SUBJECT: REVIEW OF SURVEY WORK PLAN FOR DEPLETED URANIUM (DU)  
PENETRATORS

We have completed our review of the Navy's "Survey Work Plan for Depleted Uranium (DU) Penetrators, Vieques Naval Target Range, Live Impact Area, Vieques, Puerto Rico," provided by CDR G. Higgins on January 10, 2000.

**COMMENTS ON  
SURVEY WORK PLAN FOR VIEQUES NAVAL TARGET RANGE**

TECHNICAL EVALUATION REPORT  
U. S. NAVY - VIEQUES ISLAND  
REVIEW OF SURVEY WORK PLAN

Figure 3. Affected Area of North Convoy Site and Harrier Aircraft Line-of-Fire.

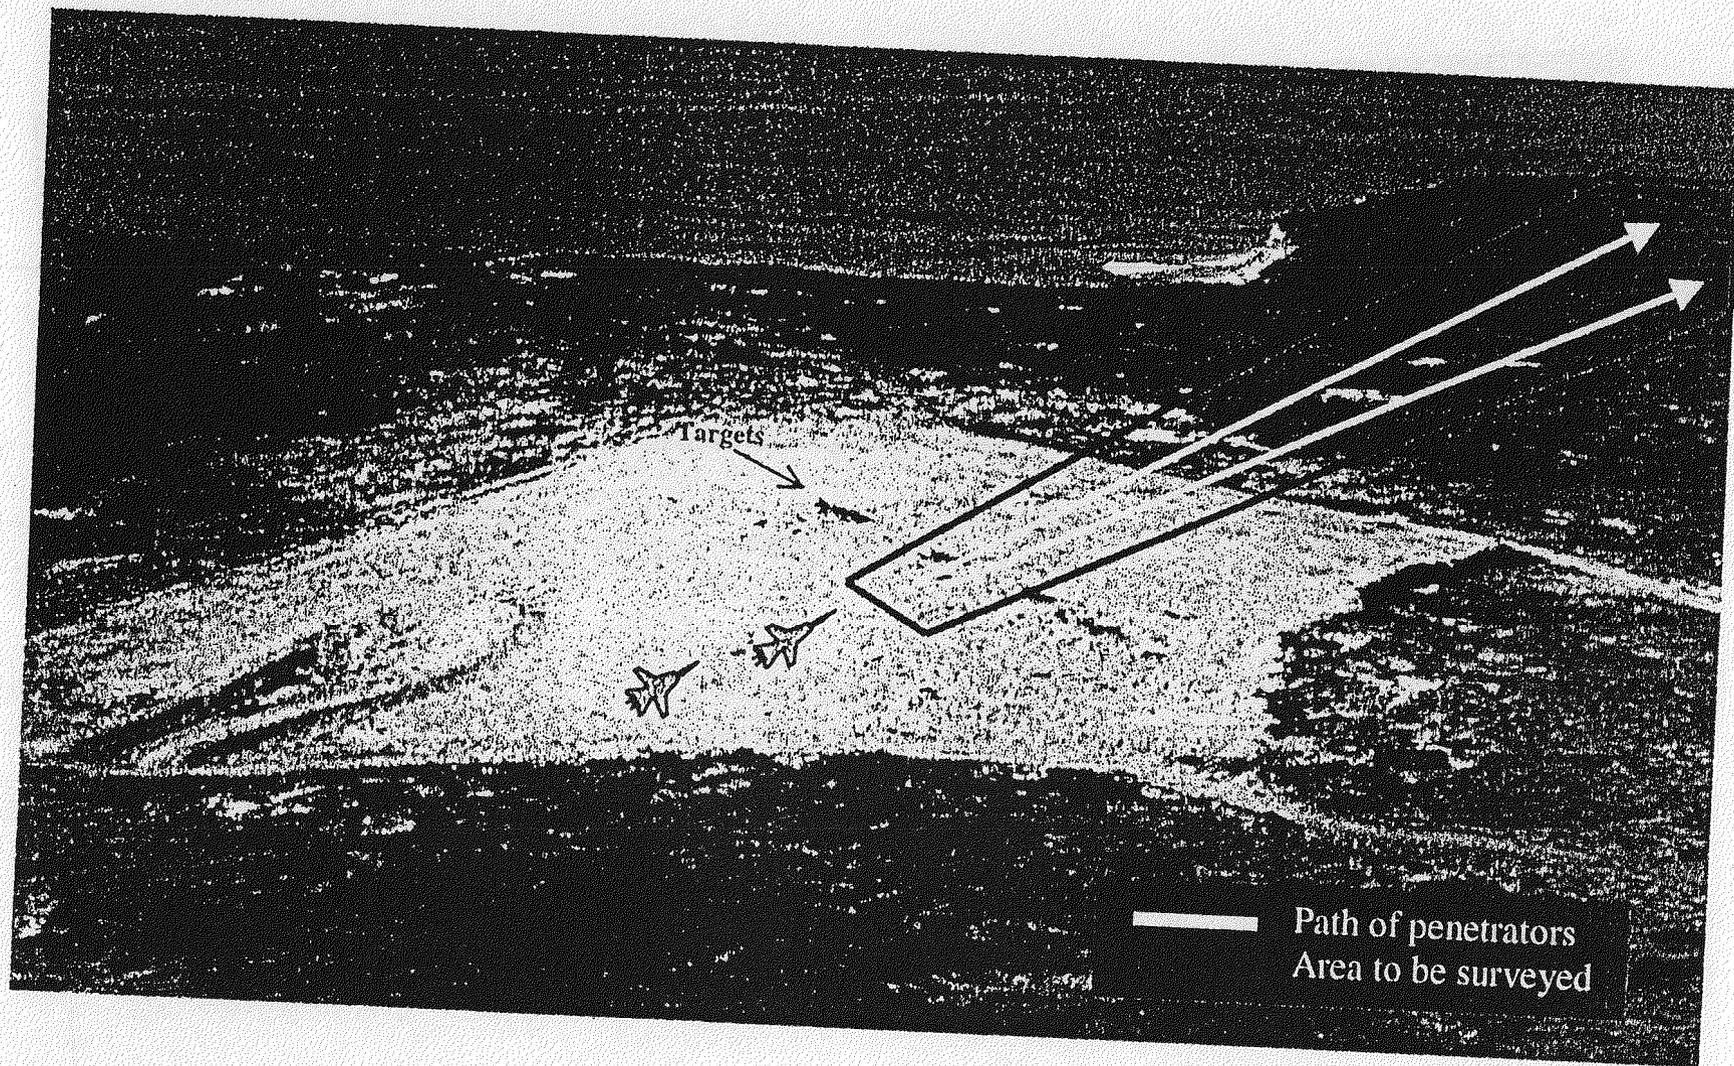
The survey area will consist of approximately 10 acres (figure 3 of the survey work plan). The plan indicates that the actual affected area may be in the range of 1.5 acres, because the DU rounds are expected to be located along two firing lines. Two soil types

Figure 8. Stack Map Used to Analyze Scan Survey Data.

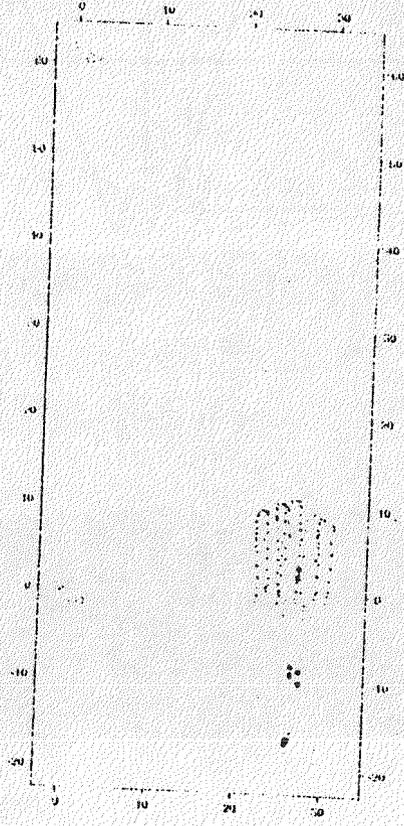
The data will be analyzed using the computer software available with the NAVTRACK system. Statistical information (high, low, mean, and standard deviation) will be calculated. A graphical review of the data will be performed using posting plots/maps and frequency plots/maps. An example of the system graphical output was provided for three penetrators located on the surface (Figure 8 of the survey work plan).
